Civic Design Review - Phase 3

BAY CORRIDOR TRANSMISSION & DISTRIBUTION (BCTD) ELECTRICAL SUBSTATION 398 QUINT STREET (DAVIDSON AVENUE near QUINT STREET)

February 8, 2021

CIVIC DESIGN REVIEW (CDR), PHASE 1 AND PHASE 2 REVIEW COMMENTS (8.17.2020)

AGAVE ATTENUATA ALTERNATIVE

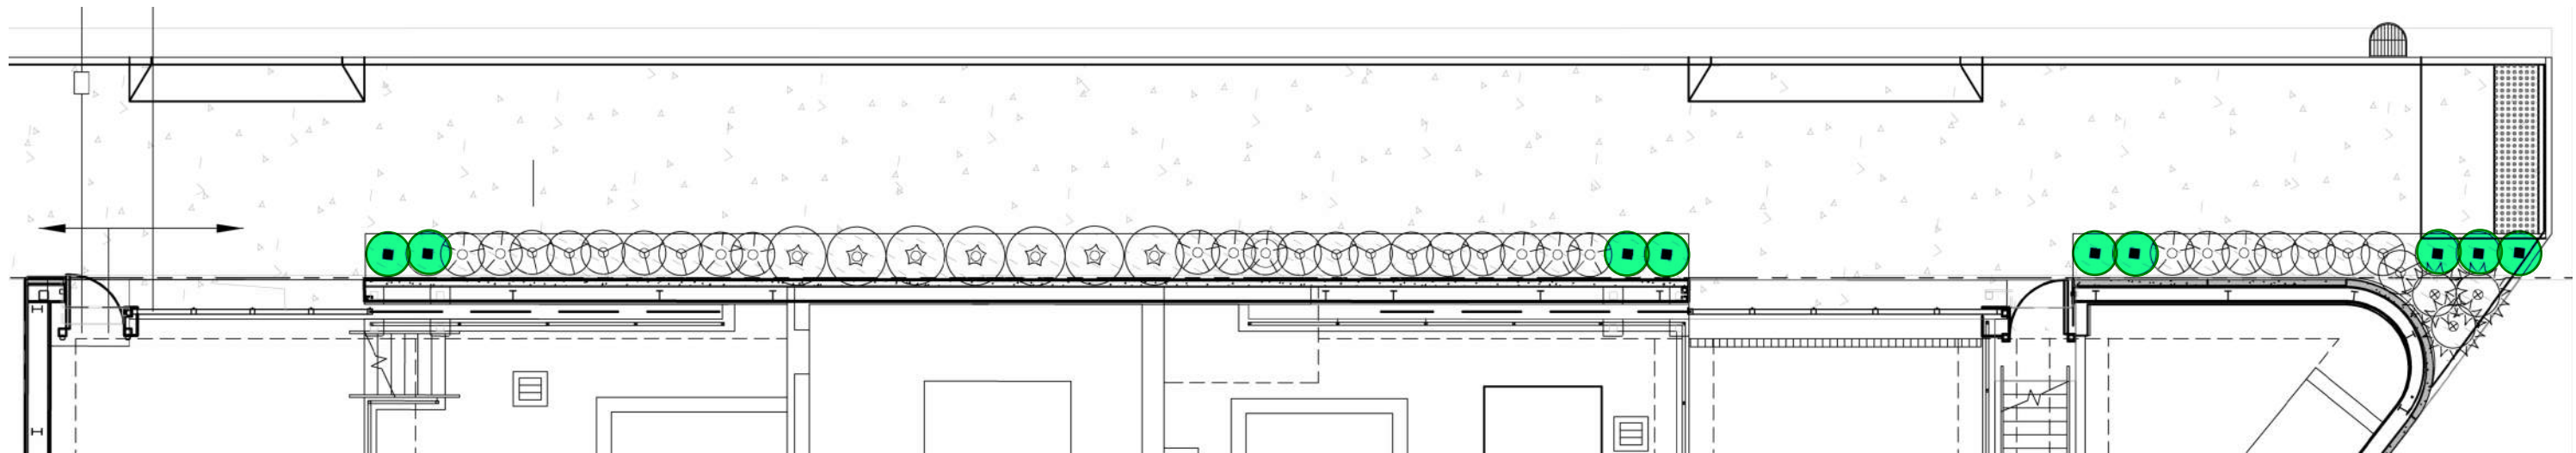
The Committee expressed concern given that it will be in a Northeast exposure.

After discussion with some nursery plant specialists, we're confident the plant will tolerate the shade given from the wall. This agave typically does well around San Francisco, and in this case, benefits include providing well-drained soil and some reflected light from the perimeter wall.

BACKLIT LEXAN PANEL QUALITY

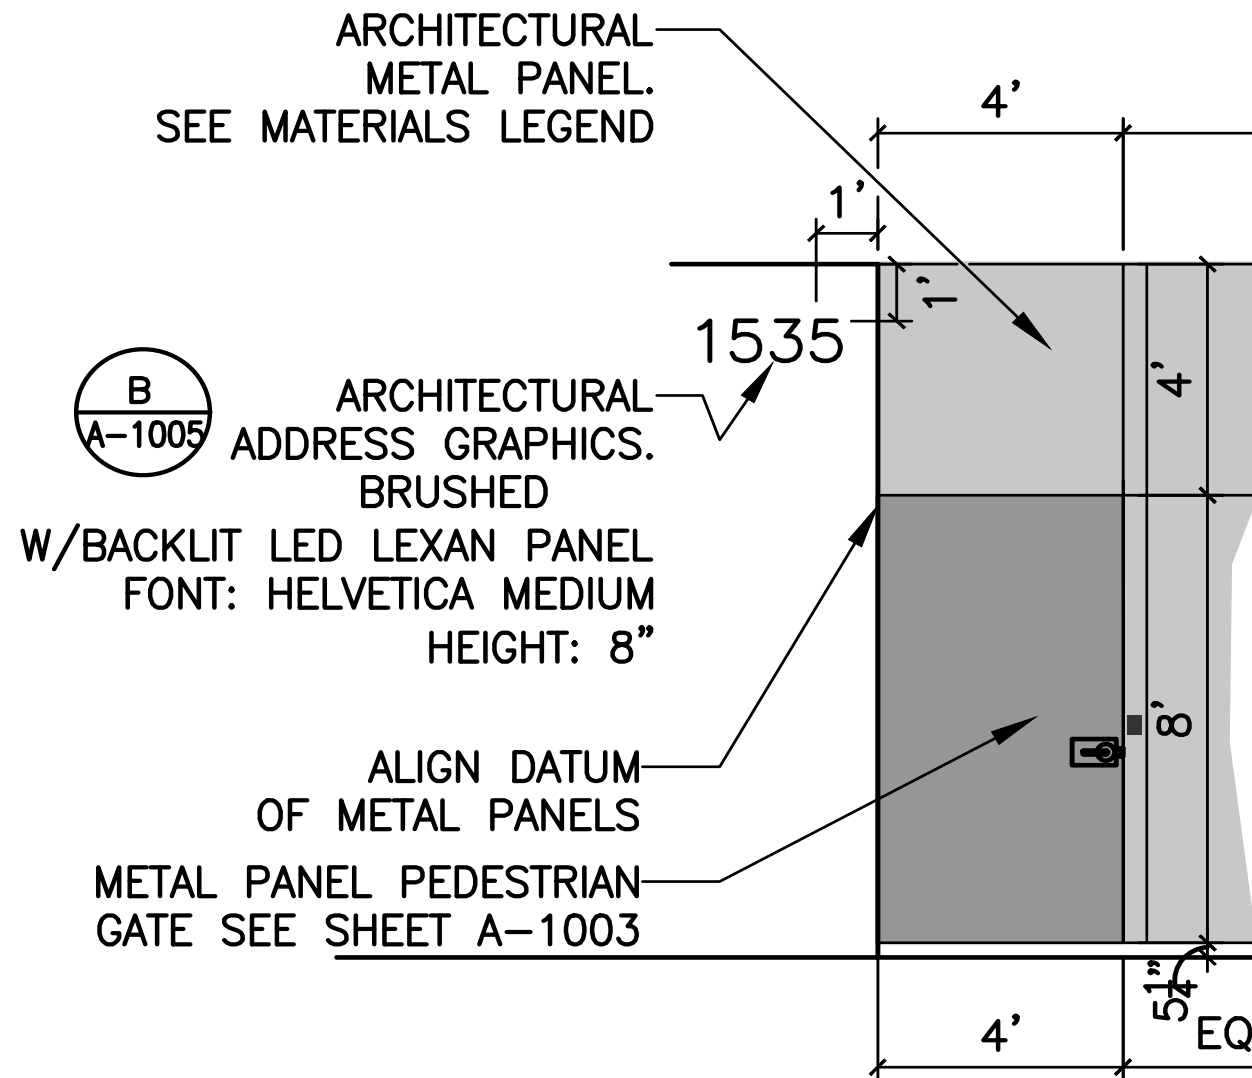
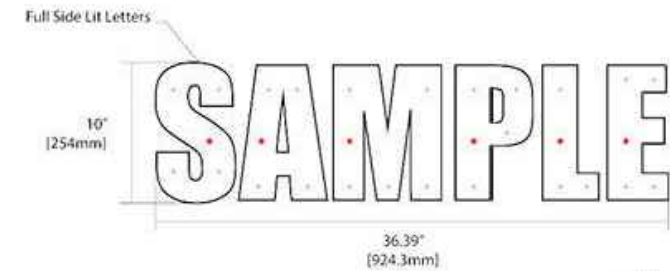
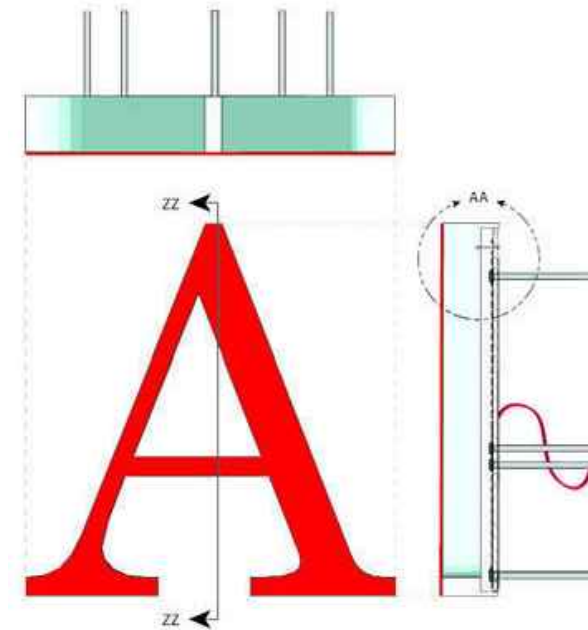
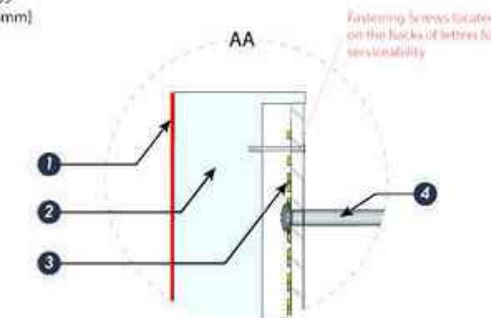
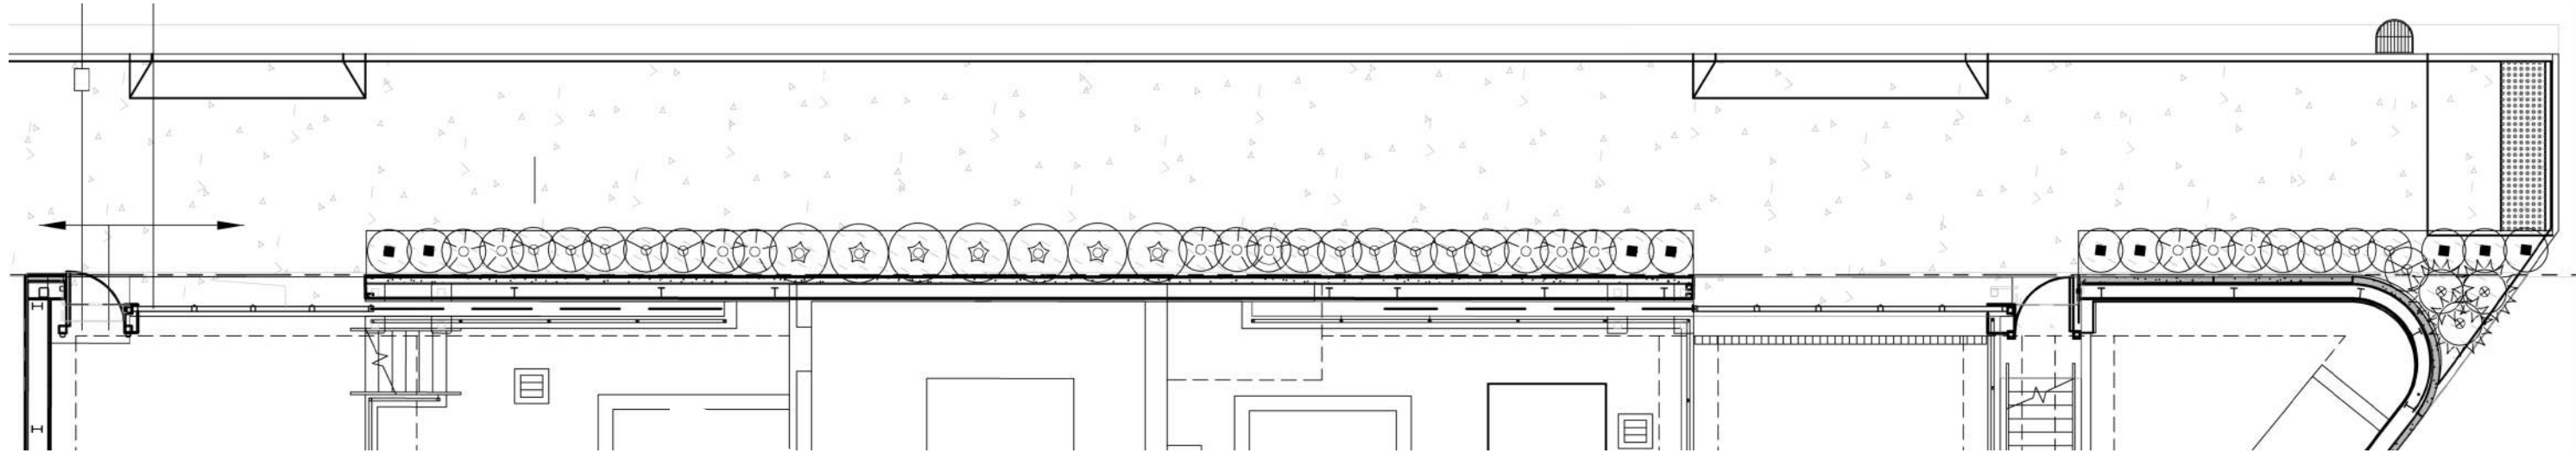
The Committee suggested that the team ensure that the illumination/light box for the graphic be high quality.

The backlit lexan panel address number proposed is from RESNO, industry leader in slim-line illuminated architectural letters.
